Port Kembla Coal Terminal Project (MP 08_0009)

Major Project Application

Responses to Public Exhibition

Submissions Report

Figure 2 – Average Hourly Weekday Truck Volumes

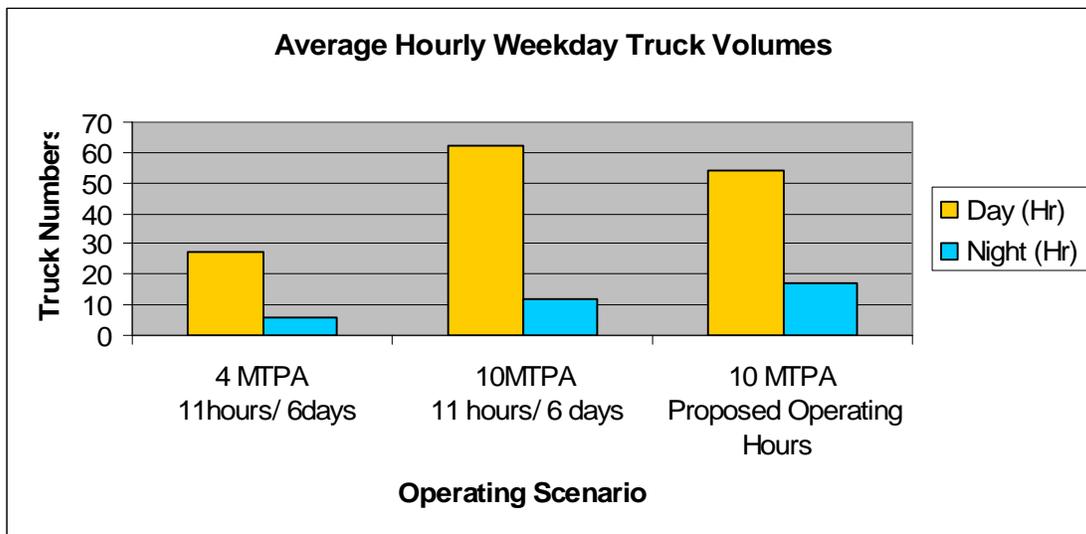
Comment: Clarification of current and anticipated truck movements entering and leaving PKCT daily and under various traffic scenarios modeled

Figure 2 shows the average weekday hourly truck numbers for the various operating scenarios. It is noted that if the current 11/6 restriction remains, and volume increases to 10 mtpa, then the result is 62 to 67 trucks per hour per direction during the day. However, if the proposed 24/7 & 15/5- 10/2 operation proceeds under 10 mtpa, then around 8 to 12 less trucks, or a total of 54-55 trucks per hour per direction, will be the resulting outcome. This is due to additional trucks able to deliver during the night hours and efficiencies in the delivery times. Furthermore, it is noted that there is currently no restriction on the tonnage delivered to PKCT, however, a voluntary restriction of 10 mtpa is proposed in the Environmental Assessment.

Figure 35 - Comparison of Future PKCT GHG Emissions

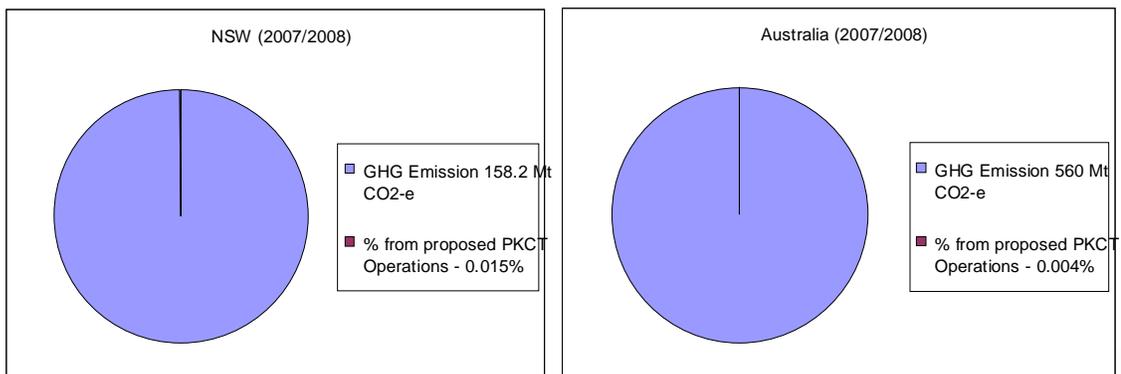
Comment: Clarification sought on calculations for Greenhouse Gas emissions

Following consultation with the DECC the Greenhouse Gas assessment has been revised, which has resulted in a reduction in Scope 1 emissions due to PKCT activities. This revised modeling and a revised greenhouse gas assessment Section of the EA is included as **Appendix B**. As a result of recalculations, GHG emissions from PKCT existing operations are expected to account for 0.012% of NSW GHG emissions, which is down from the previously calculated 0.038%. In terms of the proposed increase 10 mtpa, the contribution of PKCT to NSW GHG emissions is expected to be 0.015% which is down from the previously calculated 0.052

In calculating the relative values shown in **Table 6.27** and **Figure 35** we have disregarded Scope 3 emissions, and rather have used (Scope 1 + Scope 2) total emissions in both the
